PARTS & SERVICE NEWS

AH03511

SUBJECT: Pilot Pressure Pump Part No. 907 209 40**PURPOSE:** Good flange connection between main pump and gear pump**APPLICATION:** PC5500**FAILURE CODE:** J100Z9**DESCRIPTION:**

1.

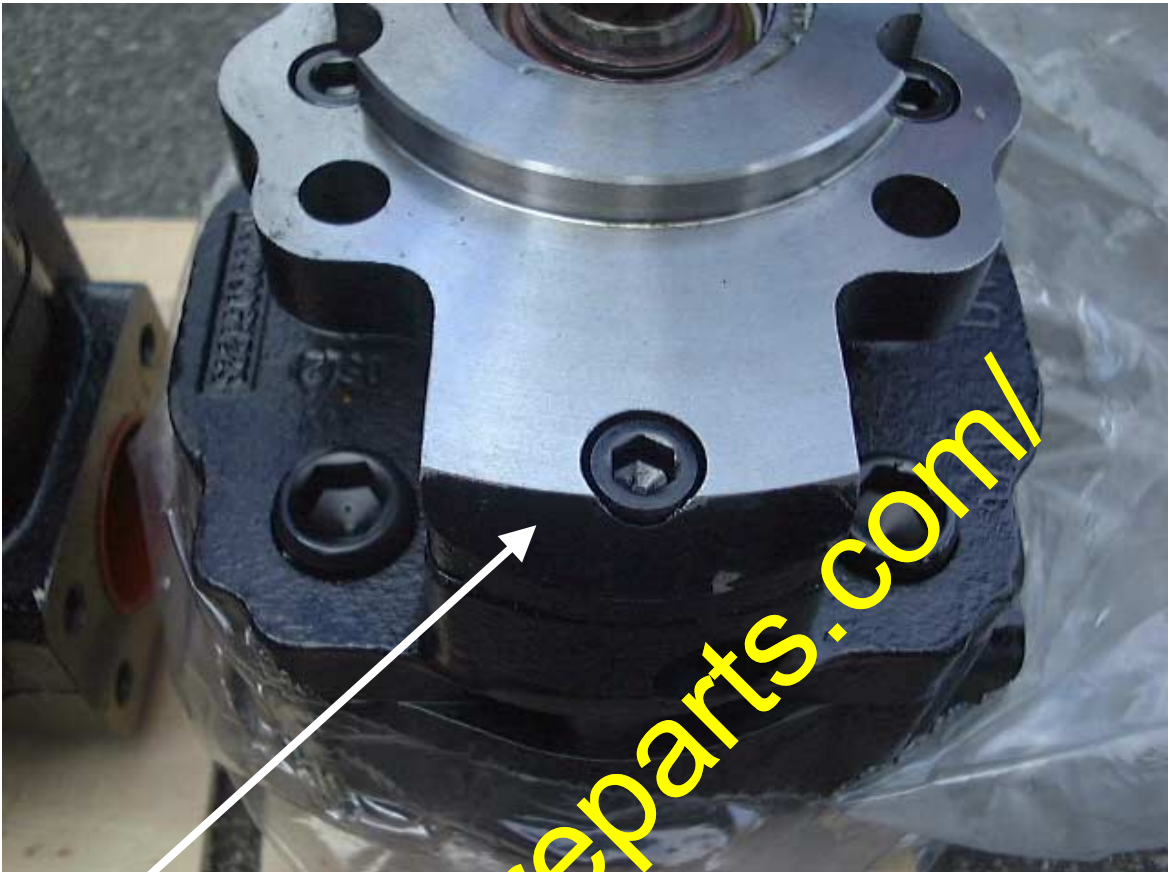
Remachine this chamfer

1. Control all new pumps before installing.
2. If necessary remachine chamfer that the face of the gear pump fit very well to the main pump.
3. Install this new pump with surface sealing agent "Loctite 510" (Part No. 461 543 40).

2.

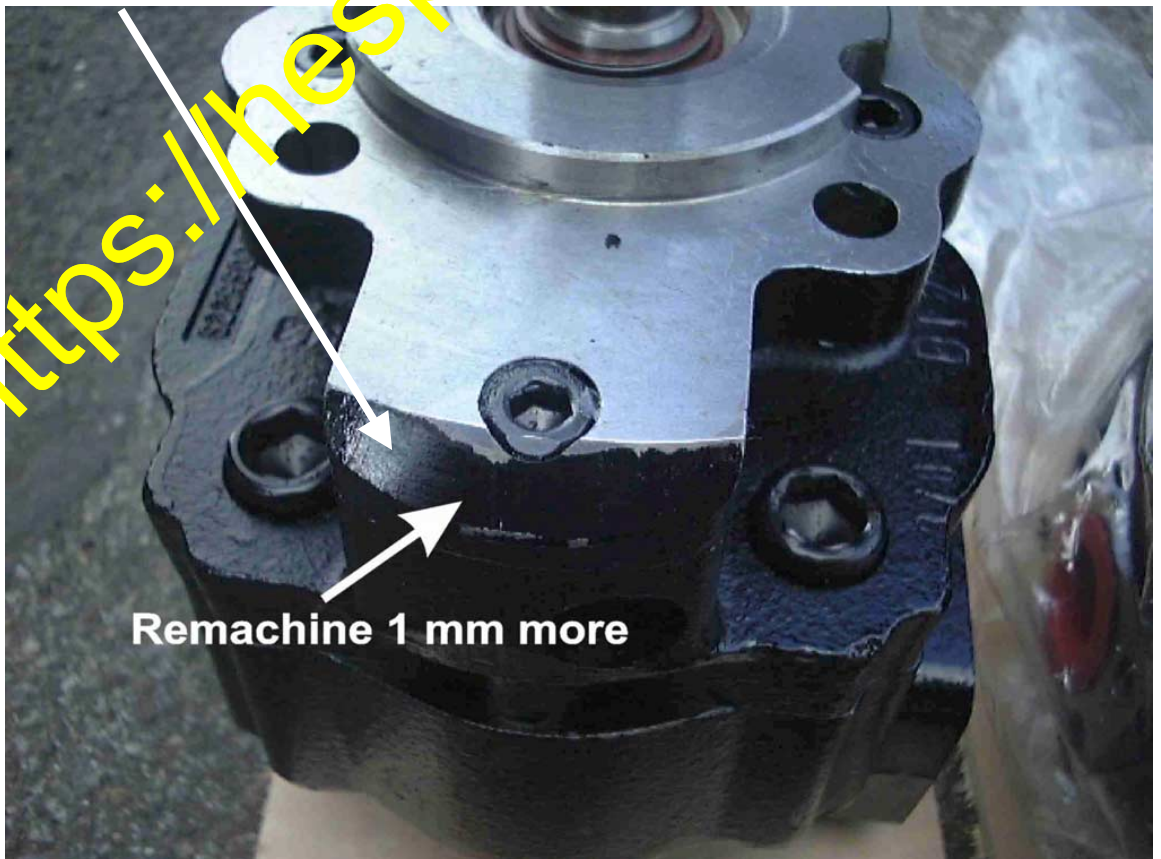
Remachine 1 mm more
